SERVICE BULLETIN

2" 3:1 Oil Pump Changes

MODELS AFFECTED: LM2203A-XX

RELEASED: 9-11-98
REVISED: 1-10-12
REV: 00
BULLETIN: #2-98
FORM: 4299-2

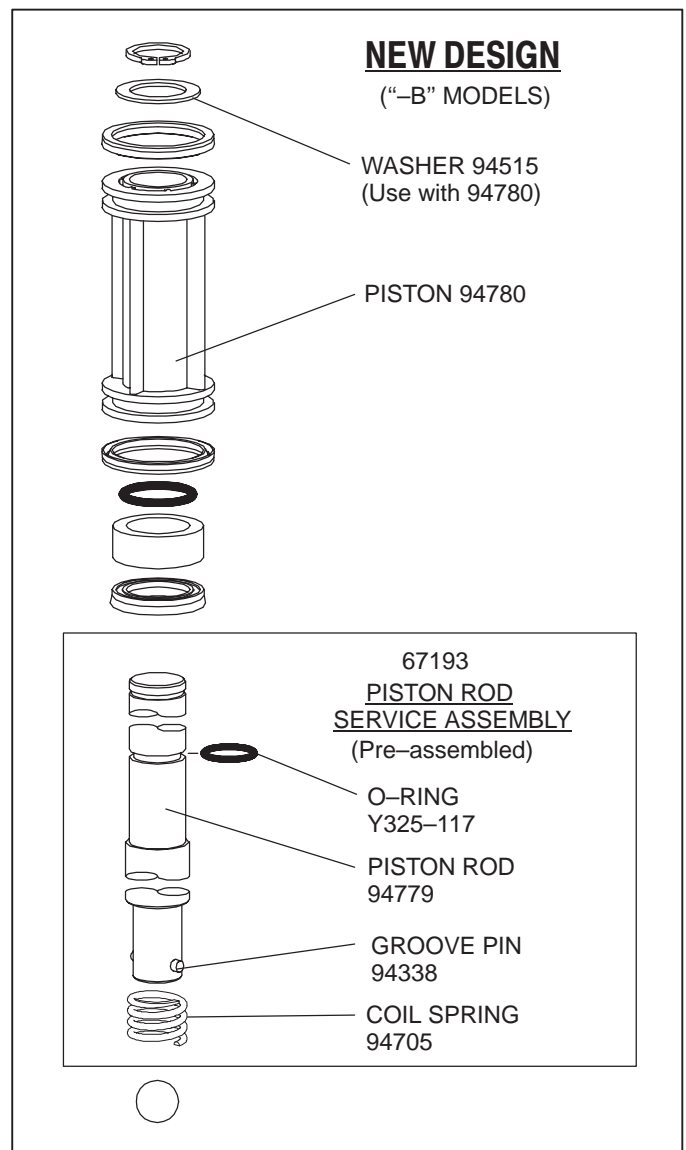
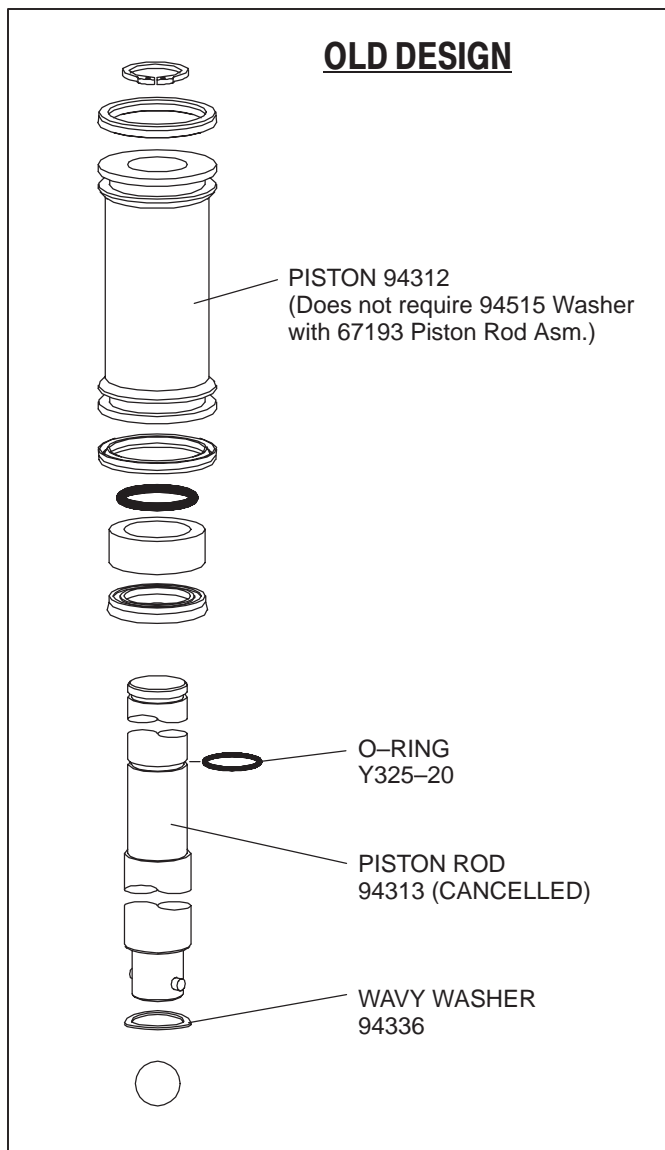
NEW PISTON ROD DESIGN - The wavy washer was replaced by a coil spring. The use of a new design piston rod assembly is required. 67193 Piston Rod Assembly is available from the factory. (Pre-assembled)

NEW FOOT VALVE BALL - The ball material has been changed to Delrin for improved priming.

- 1) Wavy Spring 94336 is replaced by Coil Spring 94705.
- 2) Piston Rod 94313 is cancelled, orders will be changed to 94779.
(Parts Y325-117, 94705 & 94338 are also required.)
- 3) Piston 94312 has changed to 94780 (molded design).
(Old design 94312 is compatible with 67193, less 94515 Washer.)
- 4) Steel Ball Y16-232 is replaced by Delrin Ball 90532-6. (Not shown)
